Request from Nelson Development 14, LLC (developer) represented by Jake Christiansen (officer) to rezone property located at 401 31 st Street. The subject property is owned by Kenneth and Shelley Brenton.				File #	
				ZON2006-00129	
Description of Action	Rezone property from "R1-80" One Family Residential District to "PUD" Planned Unit Development.				
2020 Community Character Plan	Low-Density Residential				
Horizon 2025 Transportation Plan	No Planned Improvements				
Current Zoning District	"R1-80" One Family Residential District				
Proposed Zoning District	"PUD" Planned Unit Development.				
Consent Card Responses	In Favor	Not In Favor	Undetermined	% Opposition	
	Inside Area				
	Outside Area	3	10	1	<20%
Plan and Zoning Commission Action	Approval	8-0	Required 6/7 Vote of the City Council	Yes	
	Denial			No	X

Nelson Development 14, LLC - 401 31st Street

ZON2006-00129

PRELIMINARY CONCEPTUAL PLAN FOR SOUTH OF GRAND ESTATES
 A PLANNED UNIT DEVELOPMENT IN THE CITY OF DES MOINES, COUNTY OF POLK, STATE OF IOWA
 SHEET 1 OF 3

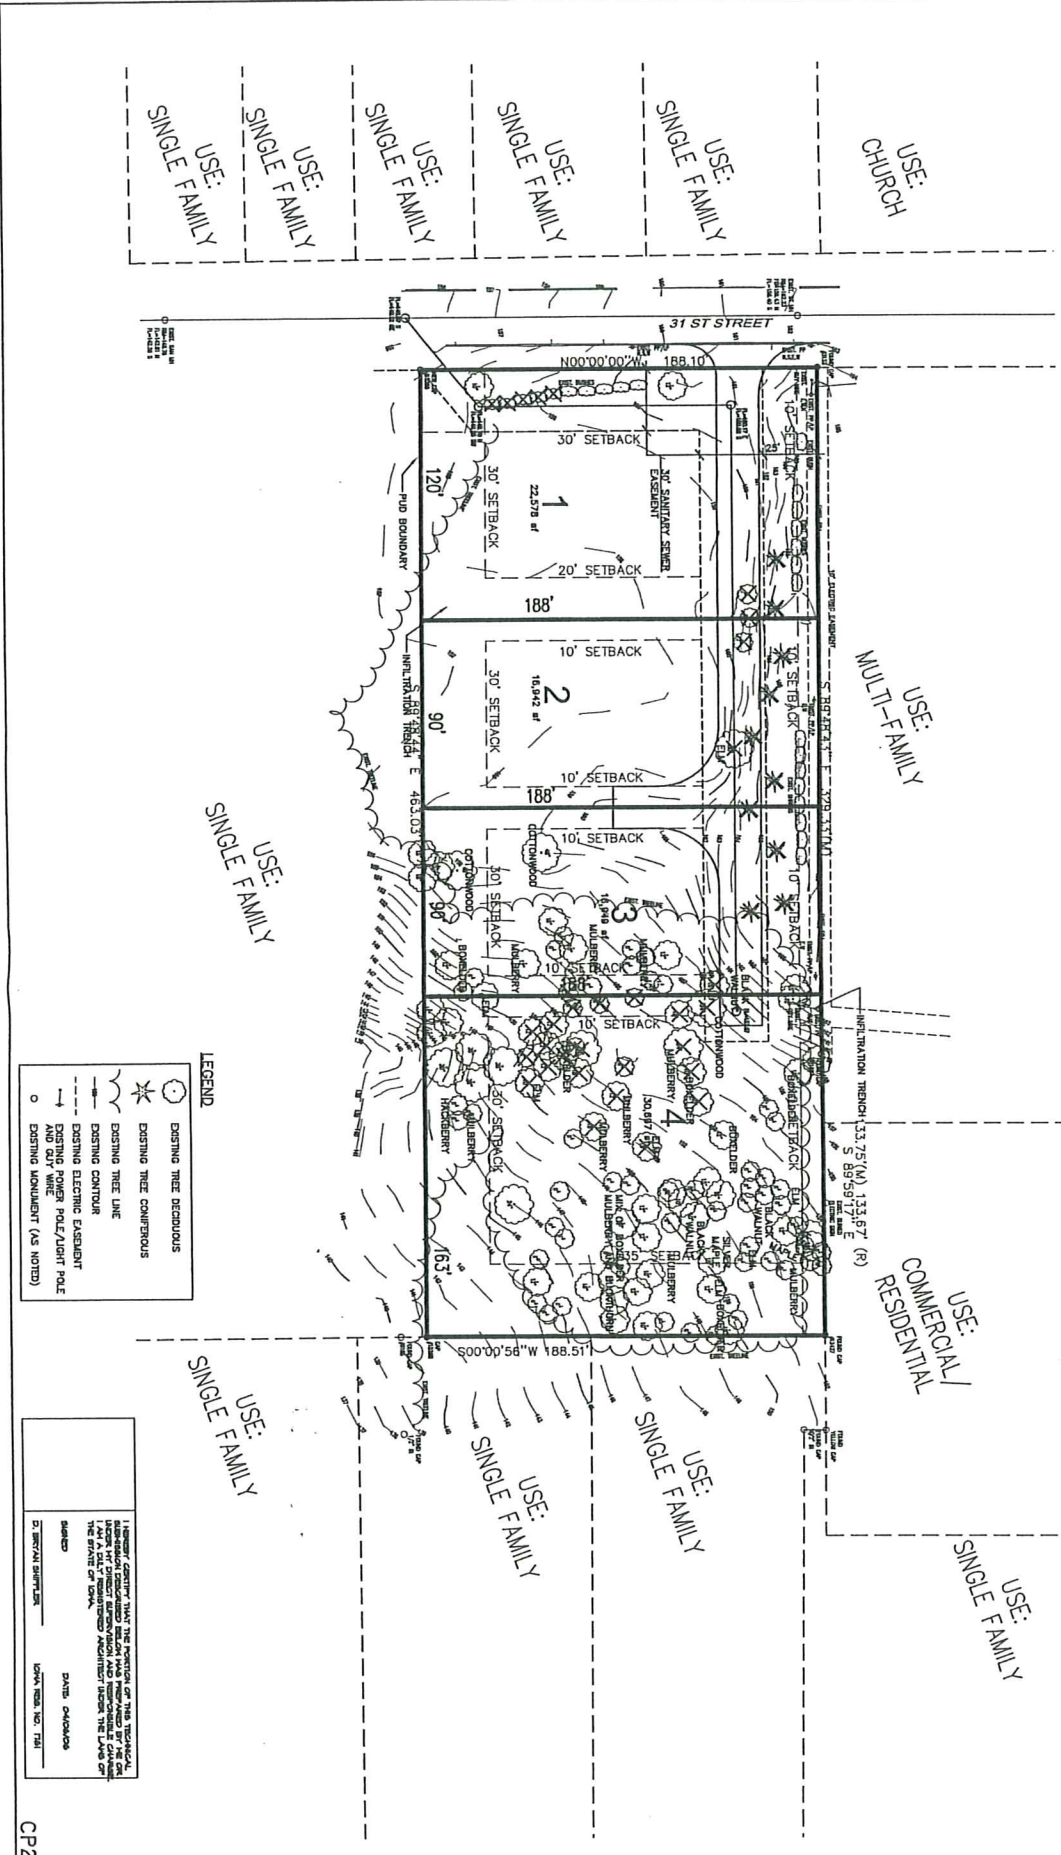
Part C) Staff recommends approval of the submitted PUD Conceptual Plan subject to the following modifications:

1. Provision for permanent conservation easements on the eastern and southern portions of parcel 4, and on the southern portion of parcel 3 to guarantee future protection of those timbered areas after single-family development occurs.
2. Provision of a statement that a tree protection and mitigation plan will be provided with any development plan/preliminary subdivision plat or grading plan as follows:

- J) No building construction shall be allowed in the reserve are.
3. Revising the storm water statement to read that storm water run-off from between the pre-developed 2-year and 100-year storm frequency will be detained on site in addition to the implementation of the stated conservation methods. Also, indicating that off-site water will be picked up and conveyed to an appropriate outlet to be released at velocities that are non-erosive.

4. Provision of proposed grading contours.
 5. Replacement of the removed evergreen plantings on a one for basis in a location north of the private drive. Replacement of the shrub line indicated for removal by the sanitary sewer installation.

6. Addition of Conceptual street tree plantings in the parkway of 31st Street at one per 40 lineal feet
 7. Provision of a note that fire lanes and turnarounds shall be prominently signed for no parking.

8. Provision of a statement that any single-family home will have a minimum square footage above the basement level and independent of the garage of 1,200 square feet for a single-story and 1,400 square feet for a two-story or greater.

9. Provision of a statement that homes on parcels 2,3, & 4 must have a primary entrance oriented toward the private drive, and the home on parcel 1, must have a primary entrance oriented toward either 31st Street or the private drive.
